REVISION				
REV	DESCRIPTION	DRAWN	APPR	DATE
IR	Initial Registration	S.Y.EUN	I.C.KIM	2021.03.24.
1	상대물 메이팅 시 JACK 삽입탈력 문제로 인한 치수 변경	S.Y.EUN	I.C.KIM	2021.08.24.
2	고객사 요청으로 메이팅 부 신호누설 개선 EMI GASKET (TROT) 구성 추가	S.Y.EUN	S.H.KIM	2022.03.23.

TOLERANCE	Decimal	DATE 2022. 03. 23.		 RF & MICROWAVE TECHNOLOGY Tel : 82-32-347-8015 Fax : 82-32-347-8017
	Angle	APPROVED BY	S.H.KIM	
MATERIAL		CHECKED BY		KJ COMTECH CO.,LTD. TITLE SMA50 (J) SMA50 (P) PUSH ON ■ SMA J/BH ADAPTOR
		DRAWN BY	S.Y.EUN	
FINISH		SCALE	4/1	DWG NO. AD00714-7/1 REVISION 2 SHEET 1 of 1
		UNIT	mm

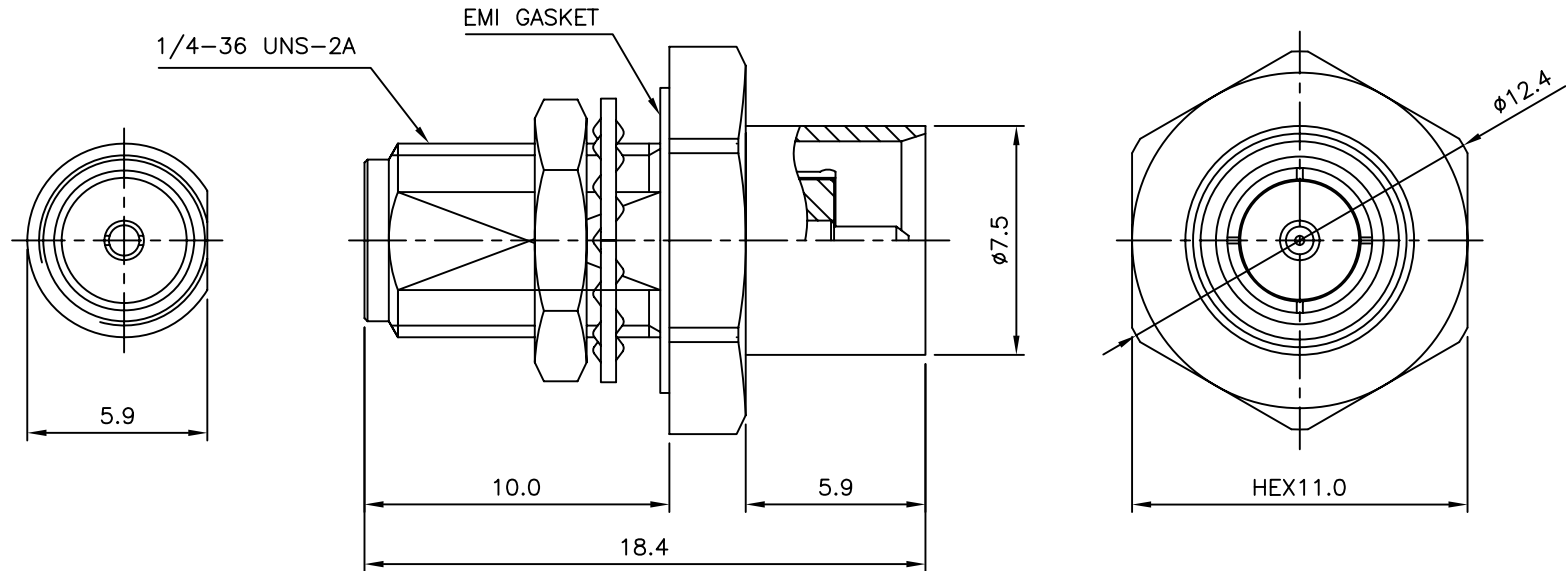
- 고객사 기구 문제로 인하여 SMA (P) PUSH 바디 외경 $\phi 7.5$ 가 최대 치수로 적용 요청
 ≫ 내부 판스프링 구조 → 바디 R 디자인으로 변경하여 PUSH 기능 구현함

■ SMA (P) PUSH 상대물 Mating Test 진행할 것

- 삽입력 : 1.25~1.35 kgf
- 이탈력 : 0.85~0.95 kgf
